MONTGOMERY COUNTY HISTORIC PRESERVATION COMMISSION
STAFF REPORT

Address:	27 West Kirke St., Chevy Chase	Meeting Date:	12/6/17
Resource:	Contributing Resource Chevy Chase Village Historic District	Report Date:	11/29/17
Applicant:	Thomas Brown (Neal Thomson, Architect)	Public Notice:	11/22/17
Review:	HAWP	Tax Credit:	N/A
Case Number:	35/13-17PP	Staff:	Michael Kyne
PROPOSAL:	Building addition

1 Site Plan
1" = 20'

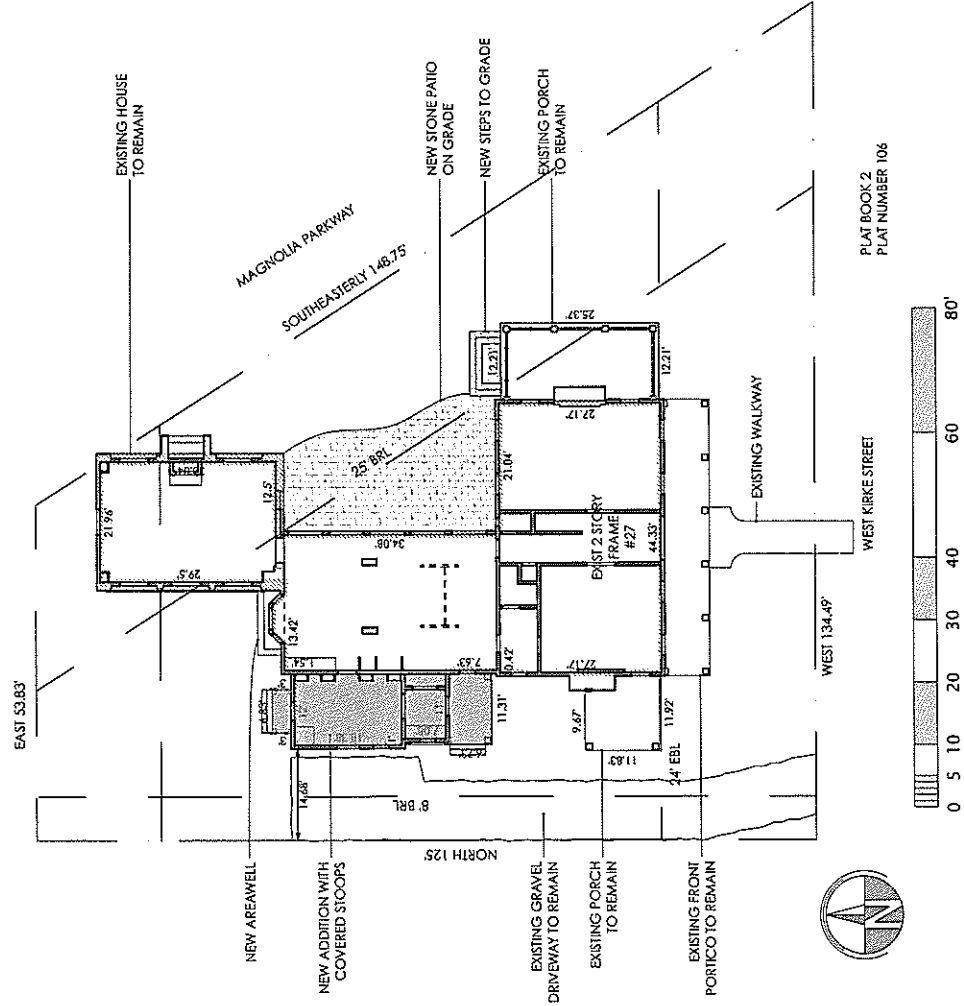
The proposed new stone patio will be at grade and at the rear of the historic house, where it will not be visible from the public right-of-way and will not detract from the subject property or surrounding streetscape.

1 Roof Demolition Plan
1/8" = 1'-0"

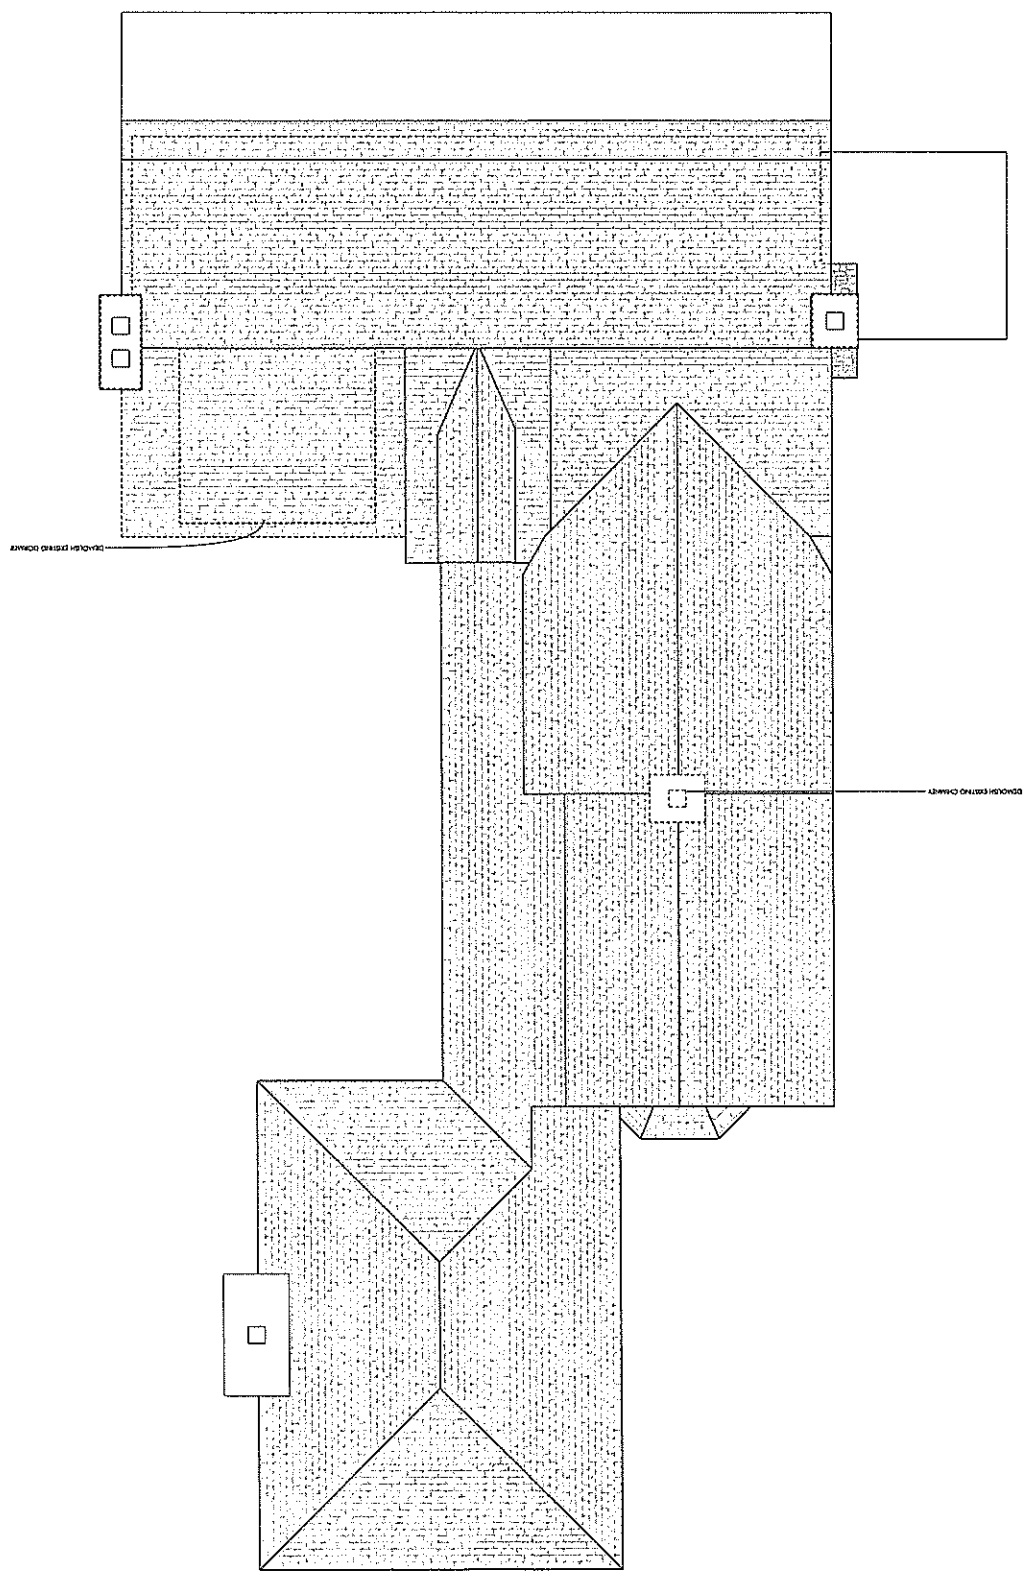
There are currently two dormers on the rear roof plane of the historic house - one historic gable dormer (rightmost dormer as viewed from the rear) and one larger non-historic shed dormer (leftmost dormer as viewed from the rear). The applicant proposes to remove the non-historic shed dormer and install a new dormer to match the historic in its place. The proposed dormer alterations are entirely at the rear, where they are not at all visible from the public right-of-way and will not detract from the subject property or surrounding streetscape.

Proposed Left Elevation
1/8" = 1'-0"

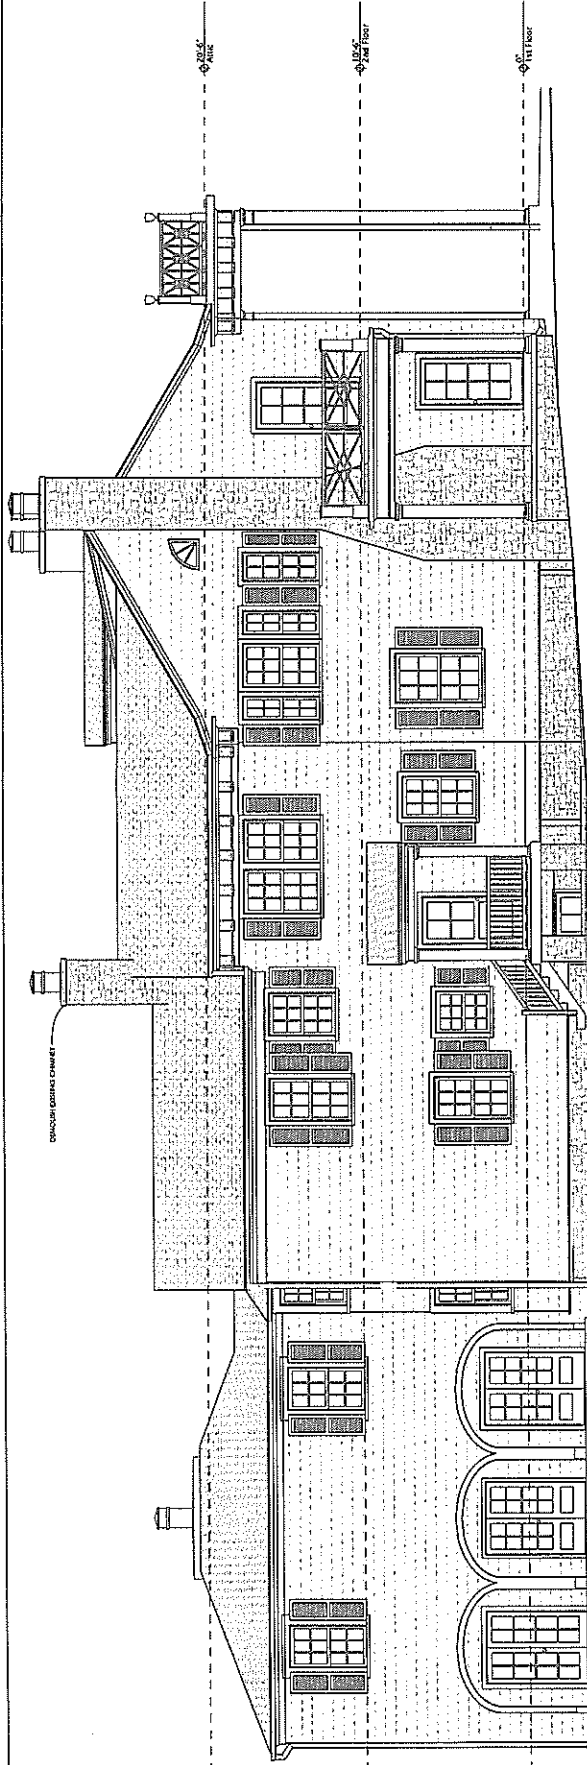
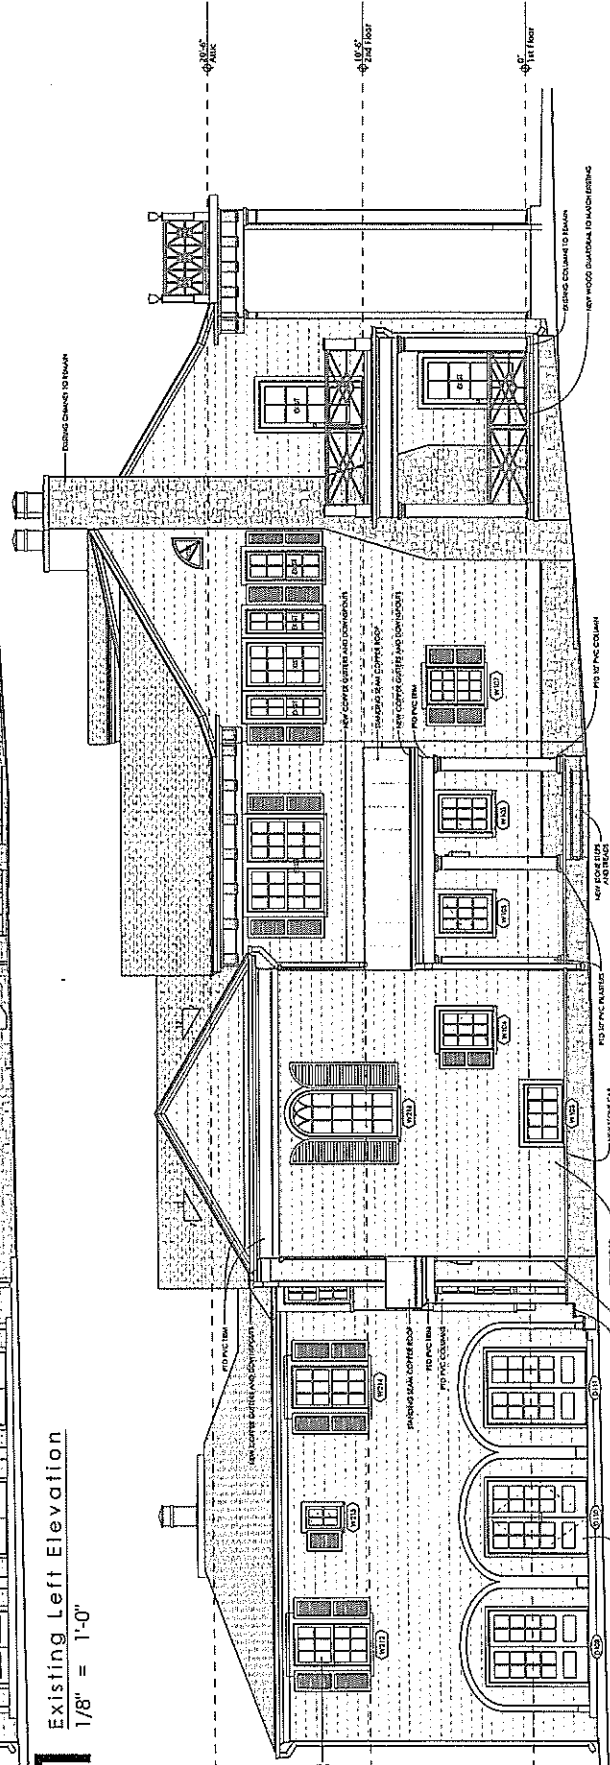
There is an existing covered porch/entrance at the left side of an existing rear addition. Although the date of construction for the existing rear addition is unknown, the applicant's architect has suggested that it has characteristics of early 20th century architecture, but is not contemporary to the historic house. The applicant proposes to remove the existing covered porch/entrance and construct a new two-story mudroom addition and covered entrance in the same general location.

The materials for the proposed two-story mudroom addition include wood siding to match the existing, PVC composite trim, SDL wood windows, wood shutters, a CMU block foundation with real stone veneer, and synthetic slate roofing to match the existing. The materials for the proposed covered entrance include PVC composite trim, PVC composite columns, and field-turned standing seam copper roofing.

Although the proposed two-story mudroom addition is not entirely at the rear of the historic house, it is located well behind the primary façade of the historic house and is relatively modest in scale (12' wide by 18.38' deep). Staff also finds that side mudrooms and modest two-story side additions are a common feature in the Chevy Chase Village Historic District.

Given the modest scale and location of the proposed two-story mudroom addition, it is unlikely to detract from the character-defining features of the subject property or surrounding streetscape. Likewise, the proposed covered entrance is compatible with the characteristics of the historic house and historic district.
